Historical Architectural Review Board
COA Preliminary Review Sheet

HDC-2025-00032

Address: 945 Turner Street

Proposal: Legalize stucco on damaged chimney

New stucco (Applicant)

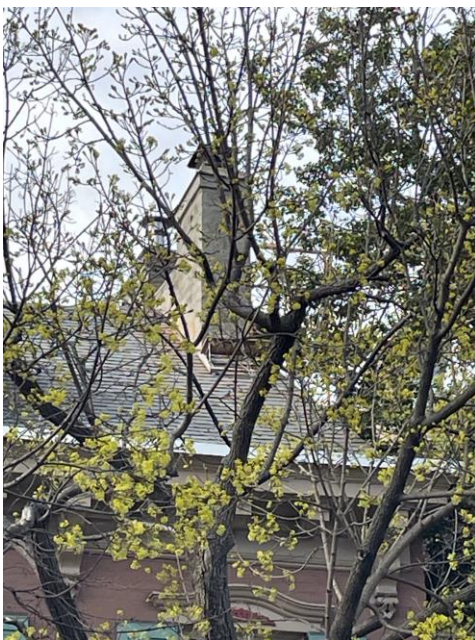
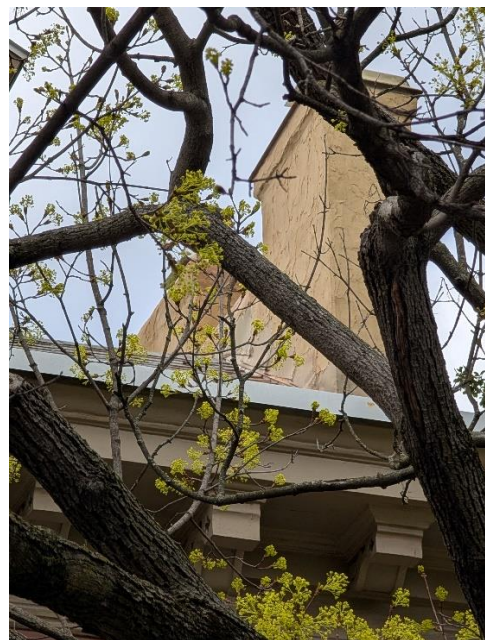
Observations & Comments: It is understood from the applicant's notes that a blockage in natural gas venting triggered the need to address and repair the venting and chimney at 945 Turner Street. The applicant notes that the chimney (which was previously painted) could no longer be re-painted, as the underlying brickwork and mortar were too severely damaged.

Per Guideline 3.1.27, adding new stucco to historically exposed brick masonry is not appropriate. A more appropriate solution to repair the chimney above the roofline would be to rebuild it, with either salvaged brick from the chimney, or new brick to match the existing in color, size, and profile, and built with mortar to match the existing in color, composition, and tooling. It is appropriate for brick masonry to be unpainted, so while the rest of the building was previously painted, a rebuilt chimney should remain unpainted and uncoated, in keeping with the Guidelines.

Mr. Hammond asked if there was an option to keep the chimney as is. Mr. Sekella said that the condition of the chimney was not safe. The applicant stated that he was unaware of the historic district guidelines or that the building was in a historic district and performed the stucco installation. Rebuilding the brick chimney was not discussed with the owner.

Mr. Hammond noted that he would prefer to approve the chimney work, as a reasonable solution for creating a safer building, and Ms. Schreier agreed. Mr. Hart is concerned that approving this repair will set a precedent. Mr. Encelewski noted that the repair is not in keeping with the Guidelines, as adding stucco where it did not exist historically is not appropriate. Mr. Jordan noted that the Guidelines indicate a chimney could be rebuilt in brick, and that the interior work to solve the safety issue is outside of the Guidelines and not under HARB review.

Staff Recommendation: Staff recommend denying.

Mr. Jordan moved to deny the applicant presented on 5/5/2025 for the legalization of chimney work at 935 W. Turner Street as presented, finding noncompliance with Guidelines of Historic Districts: Chapter 3, Section 3.1 Roofs, and found no circumstances unique to the property.
